1. PCI Standard Hot-plug Engineering Change Notice – SHPC Extensions for PCI-X 2.0

TITLE:	SHPC Extensions for PCI-X 2.0
DATE:	February 27, 2003
AFFECTED DOCUMENT(S):	PCI Standard Hot-Plug Controller and Subsystem Specification, Revision 1.0
SPONSOR:	Alan Goodrum, Hewlett-Packard, and Sridhar Muthrasanallur, Intel

Figure 4-20: Slot Status Field

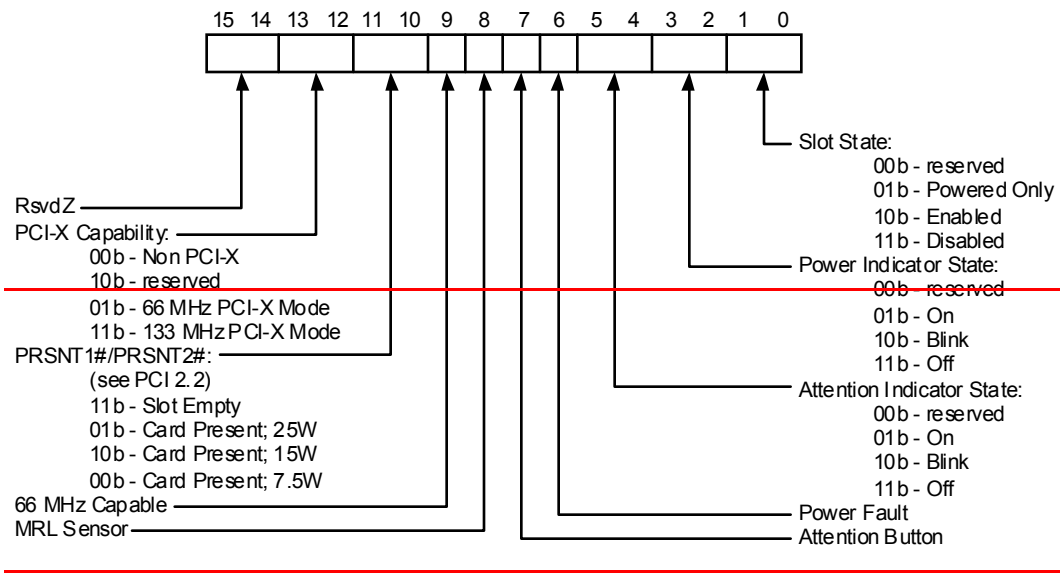
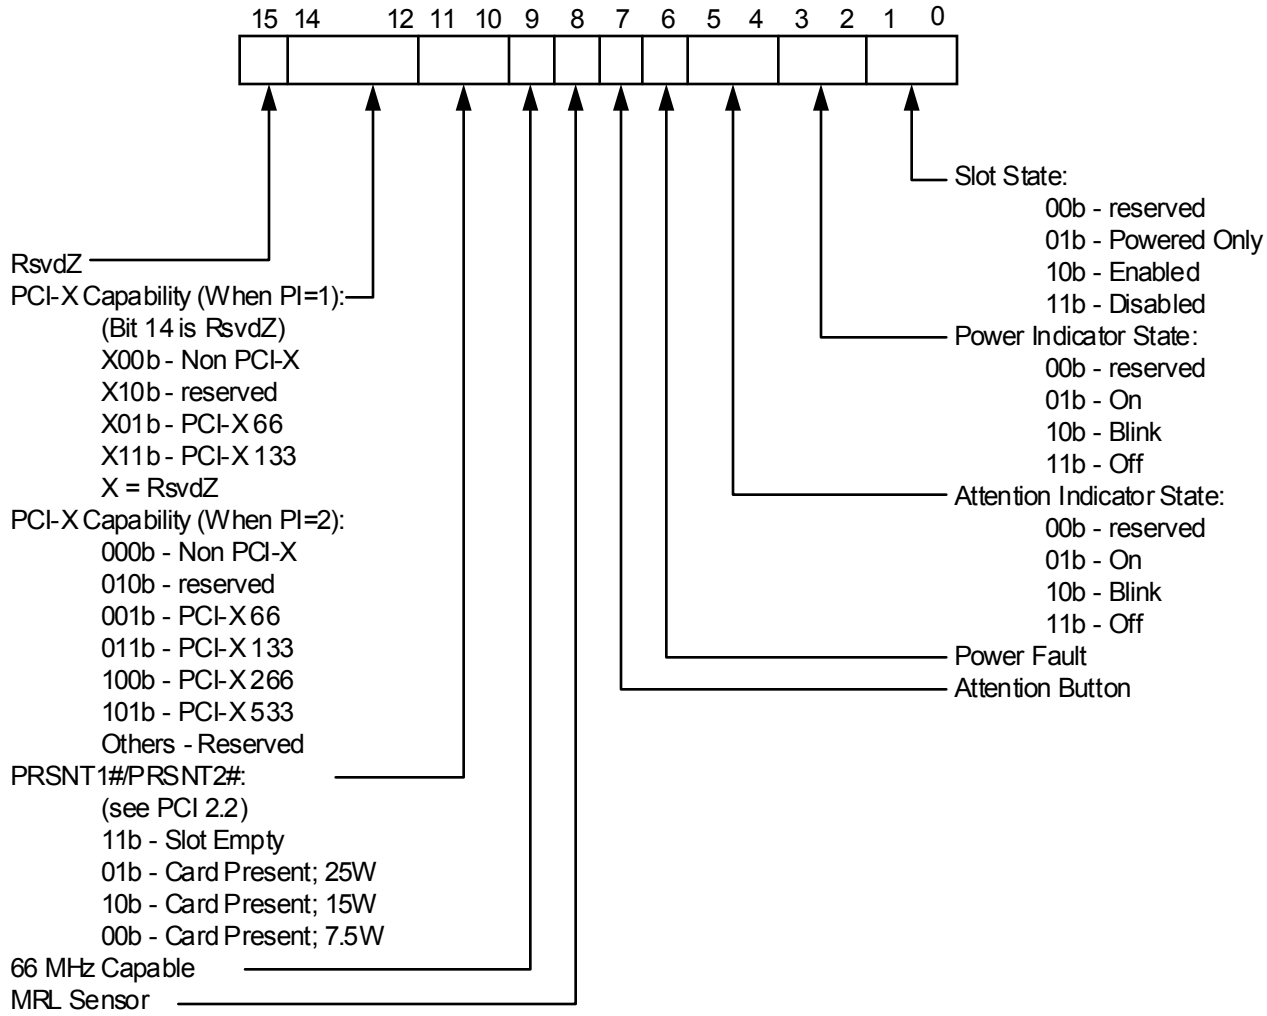
Change Instruction: Change Section 4.5.12.1 pg 124, as follows:
